CITY PLAN COMMISSION STAFF REPORT

The Dotte at Metro North

CD-CPC-20214-00071

Plan Conditions, Corrections, & Suggestions Report

C.002

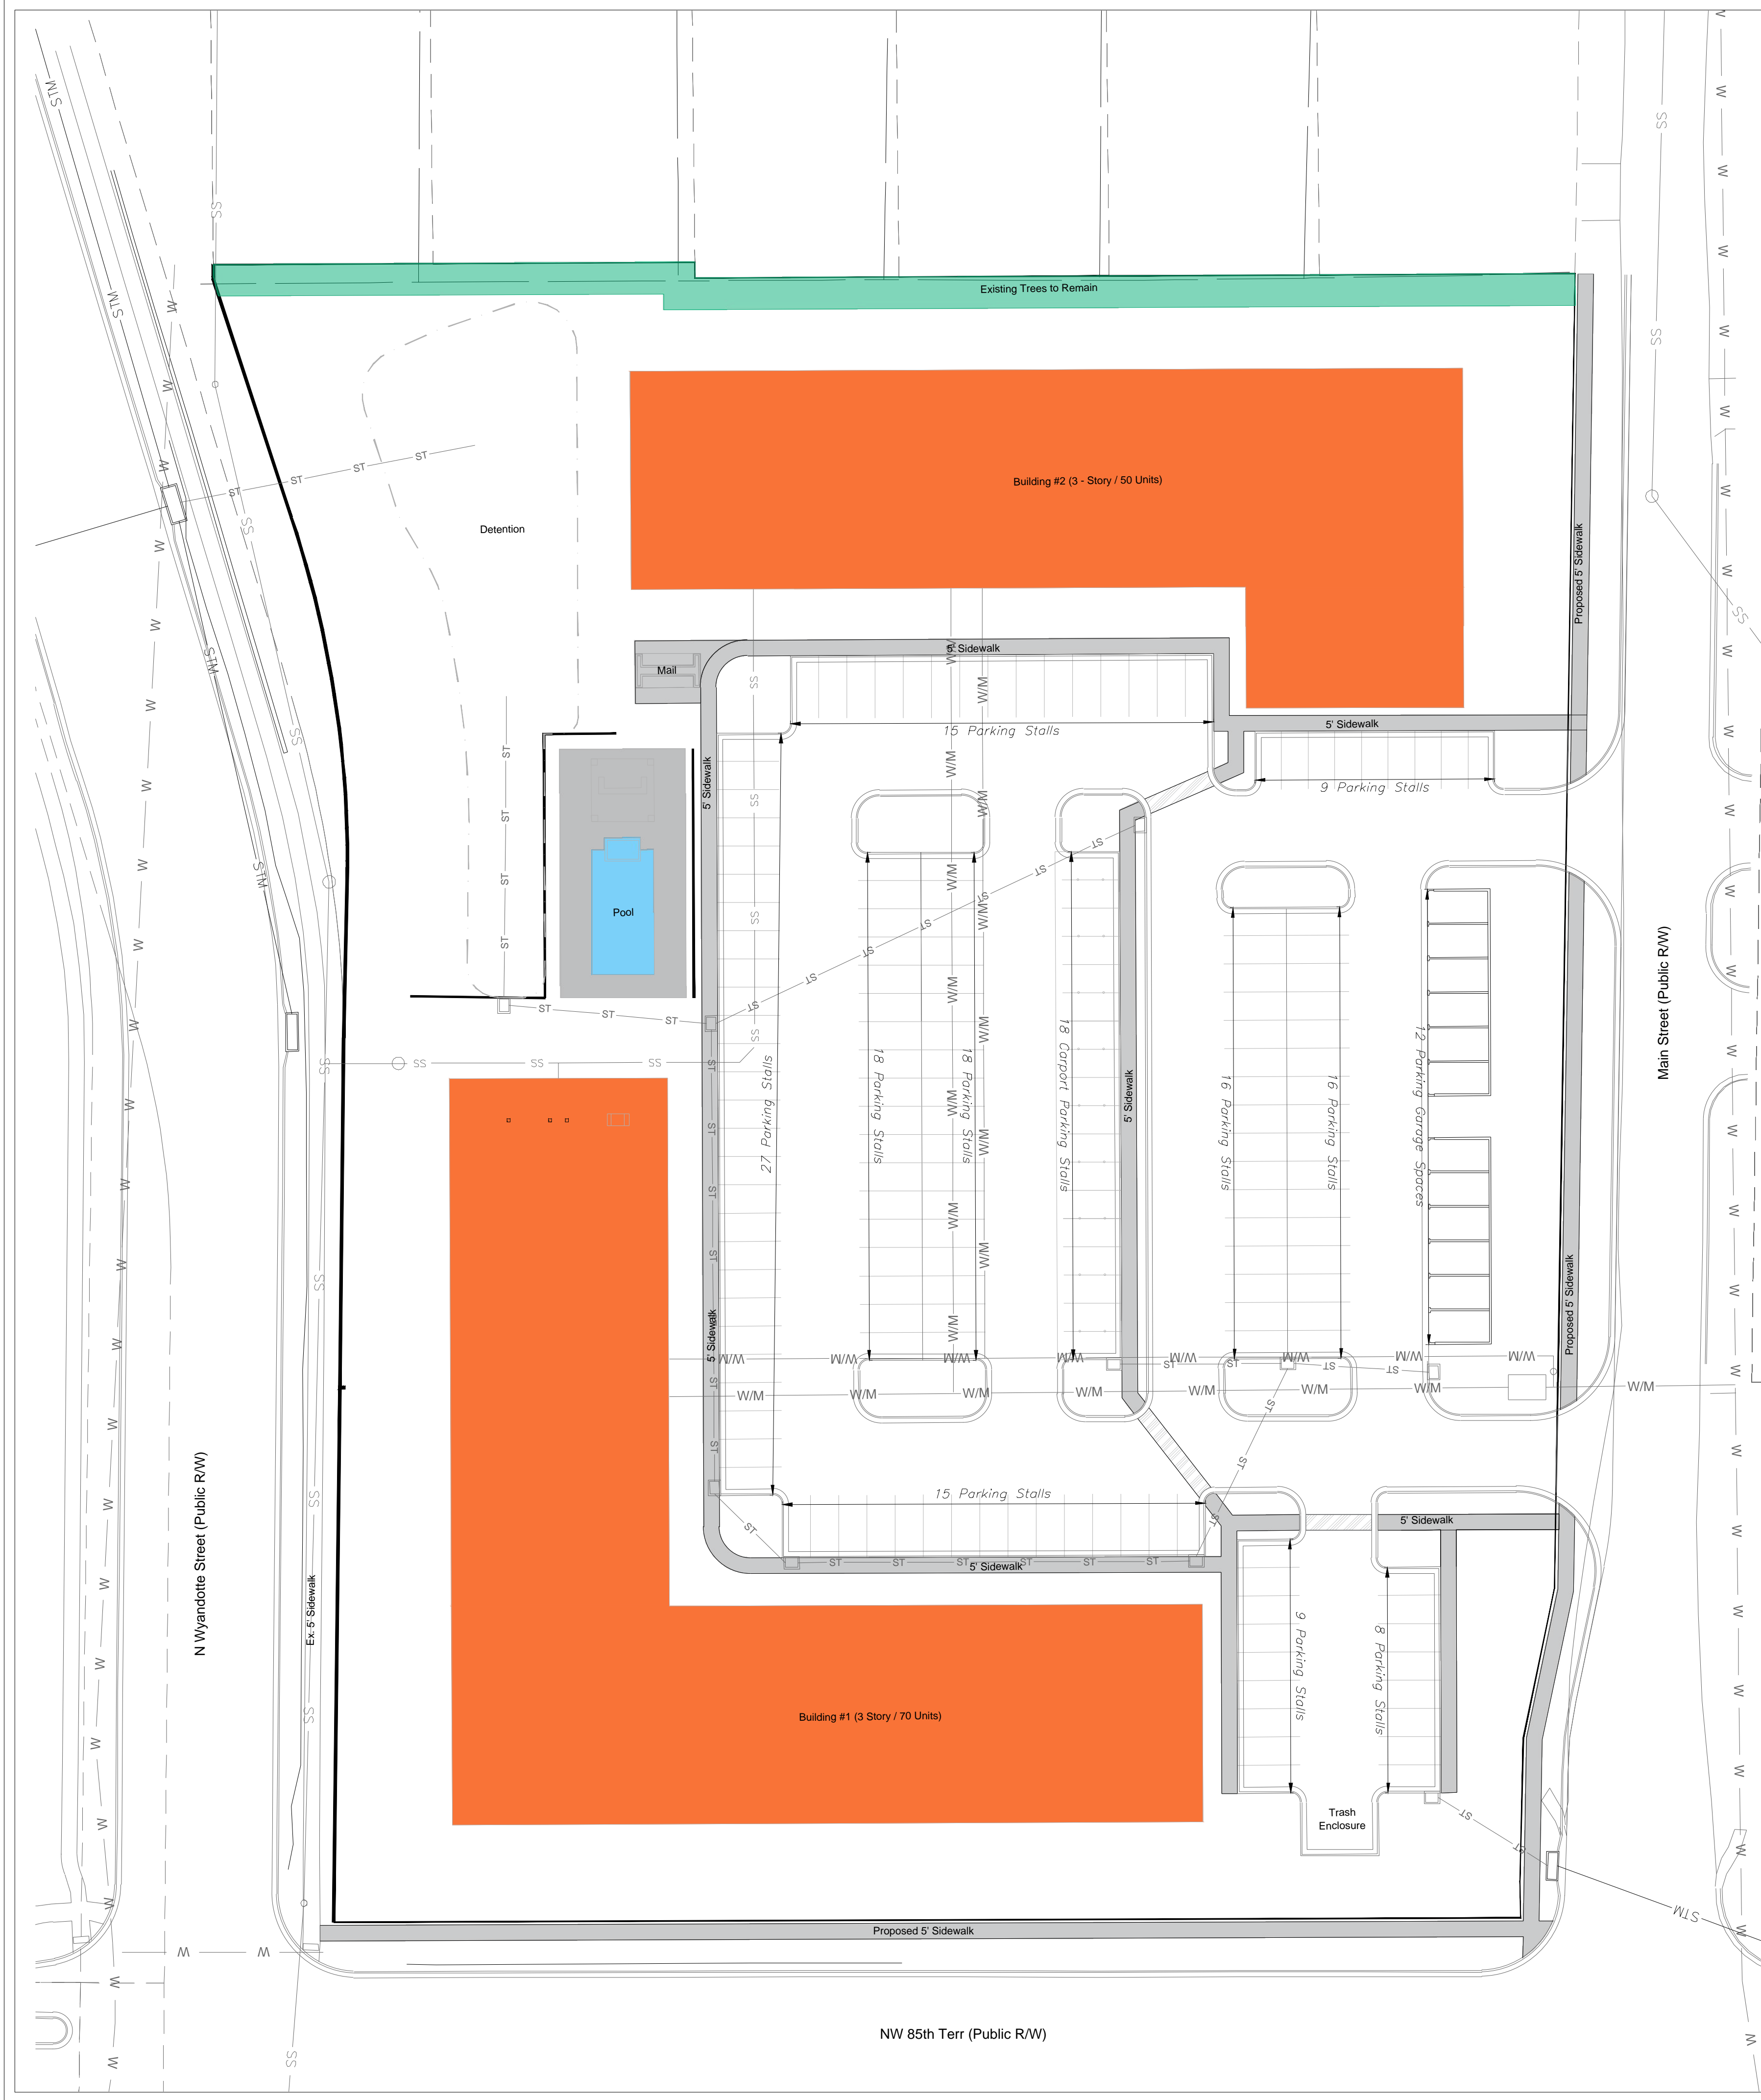
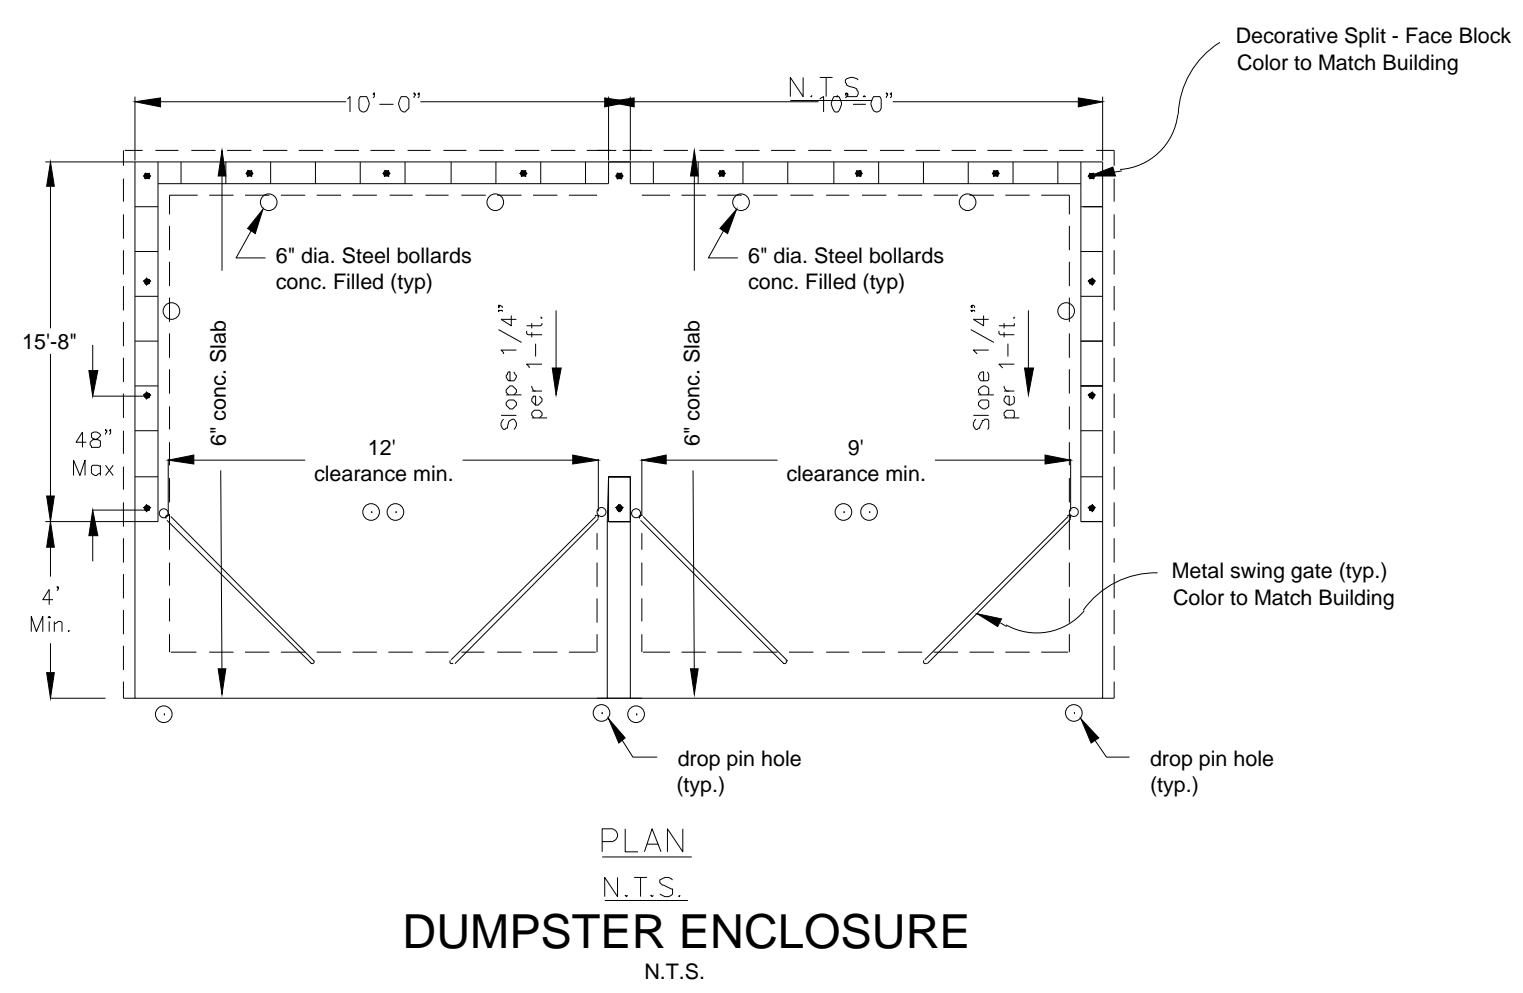
5. Add a note to the drawing of existing trees to be removed. UPDATE 7/1/24: The label on C.002 should be changed from "Ex. Tree Mass" to "Ex. Tree Mass to be Removed" (6/28/2024)
6. UPDATE 7/1/24: 12 trees are required for mitigation based on 2" caliper trees, not 8. Revise tree mitigation plan (C.002) and landscape plan (L.100). Additionally, landscape plan indicates 3" trees and all should be 2". (6/28/2024)

C.100

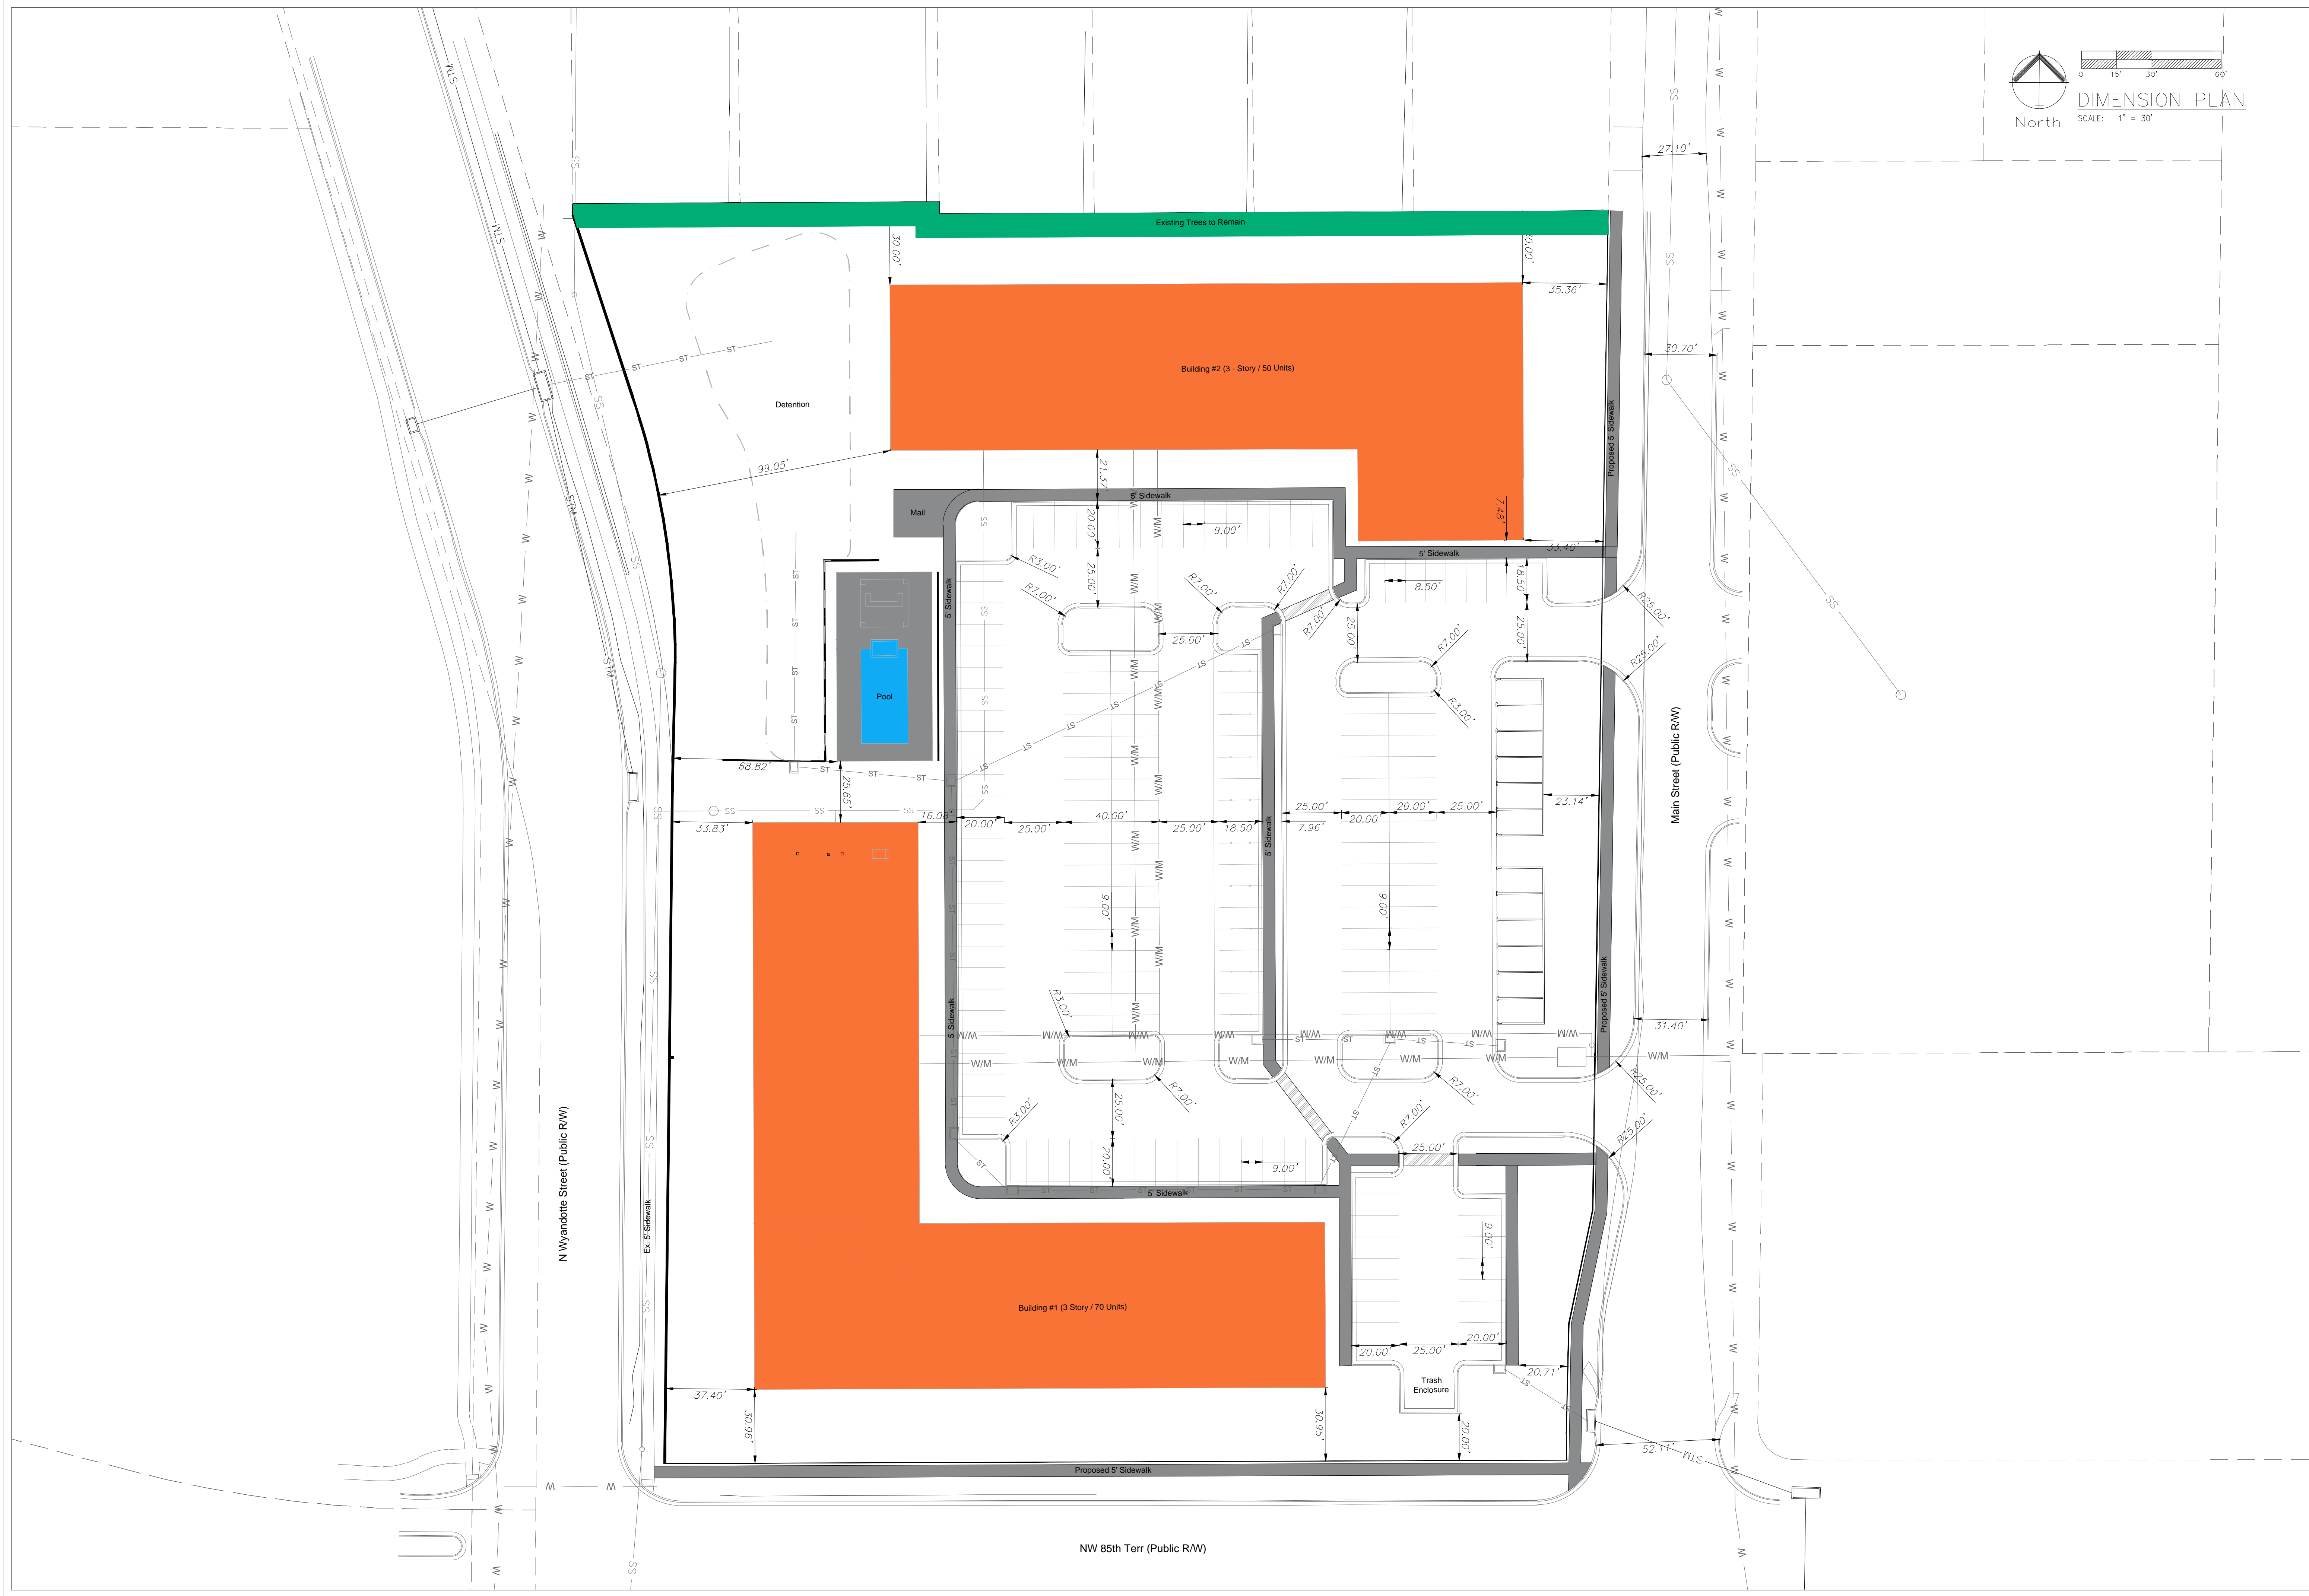
The site layout is slightly excessive in impervious area where the parking is located. The proposed number of parking spaces exceeds what's required by 60 spaces. Staff requested the applicant remove

the 17 spaces at the southeast corner of the site to improve the aesthetic and view of the corner, but they chose not to revise per staff's request.
